Groundwater Transfer Review Summary Form

Transfer/PA # T- 14450

Application: T-14450

Applicant Name: City of Banks

Cross-section : W-E, proposed APOA "AN Well" and WASH 79189**Theis Drawdown Analysis, Authorized POA WASH 62373 to WASH 79189****Theis Time-Drawdown Worksheet** v.5.00

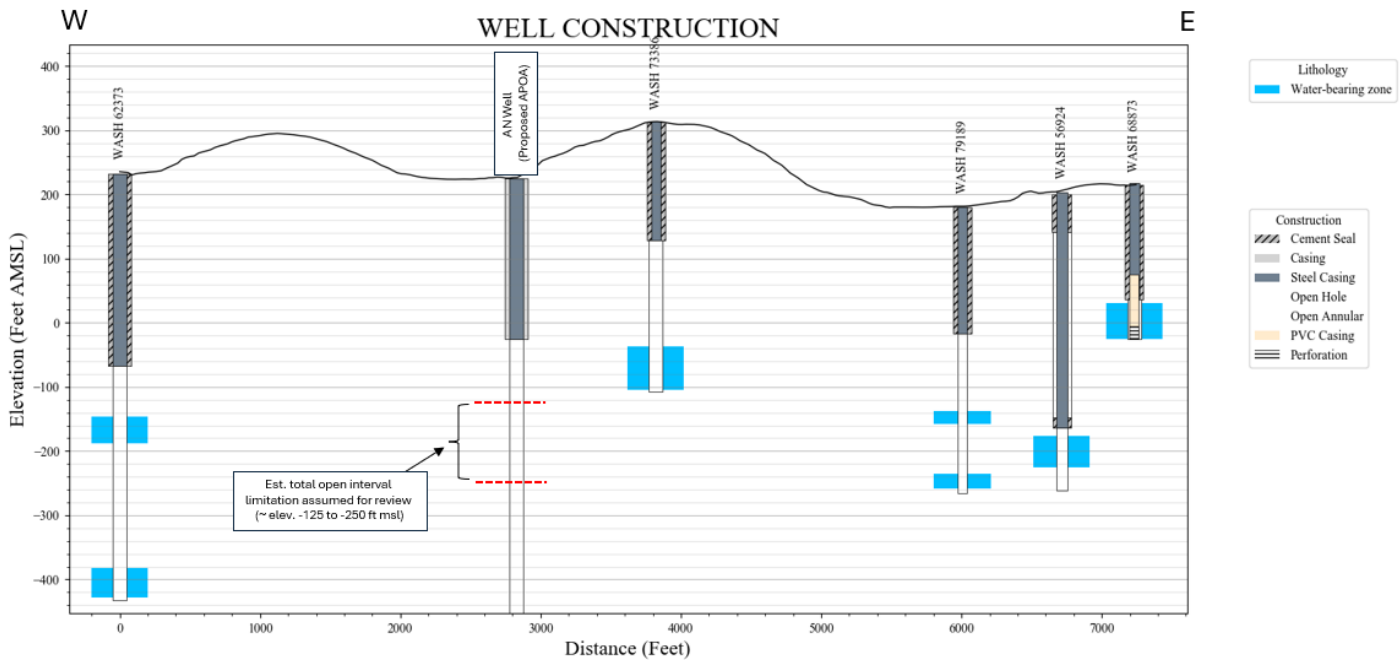
Relative to the location of authorized POA WASH 62373, the proposed location for the “AN Well” is about 2700 feet nearer to WASH 79189. The results of the Theis interference analysis indicates that additional interference in WASH 79189 could potentially range from about 10 to 50 feet due to pumping the stacked maximum rate (1.67 cfs) 24/7/365 from the “AN Well” (see attached Theis analysis results). Limited water level data from other nearby wells (WASH 56924) indicates that the static water level in WASH 79189 likely ranges from about elevation 180 to 200 ft msl, which would provide roughly 200 feet or more of available drawdown in both it and existing wells of similar completion (i.e., those wells that fully penetrate the upper WBZ present from ~ elevation -125 to -250 ft msl). This approximate range of available drawdown should be sufficient to support ongoing usage of these wells with the change proposed by this application (i.e., the change will not prevent those wells from receiving the groundwater to which they are legally entitled).

The results of the potential injury evaluation suggests that relatively moderate (~10-50 feet) levels of additional drawdown might be imposed in some area wells due to pumping of the “AN Well”, and possibly at other proposed APOA locations. It should be noted, however, that these estimates were completed using very conservative operational parameters for the Theis analytical drawdown method: pumping a single well at the full allocated rate (and in this case a stacked rate) for 24 hours a day, 7 days a week, 365 days a year. Actual pump operation will likely not be this sustained, and/or could be rotated to different locations to distribute overall pumping stresses to the CRBG aquifer system.

Theis Drawdown Analysis, Proposed APOA "AN Well" to WASH 79189**Theis Time-Drawdown Worksheet** v.5.00

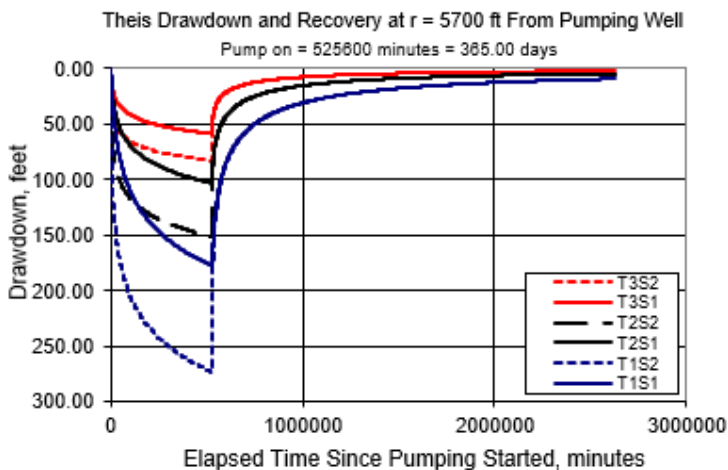
Because it is not currently known which of the two primary WBZ will be developed in the APOA wells proposed by this application, a potential “worst case” scenario was evaluated for injury potential. This scenario consists of pumping from the proposed “AN Well” location from the upper WBZ only; the “AN Well” location is relatively near to existing wells that obtain groundwater primarily from that same WBZ: WASH 79189 and WASH 56924 (see attached cross-section). Furthermore, because the same “AN Well” location (as well as WASH 62373) was also proposed as an APOA in transfer application T-14449, that well could be authorized to pump a stacked rate of 1.67 cfs (equal to 0.67 cfs from T-14449/permit G-7593, plus 1.0 cfs from this application T-14450/certificate 95849).
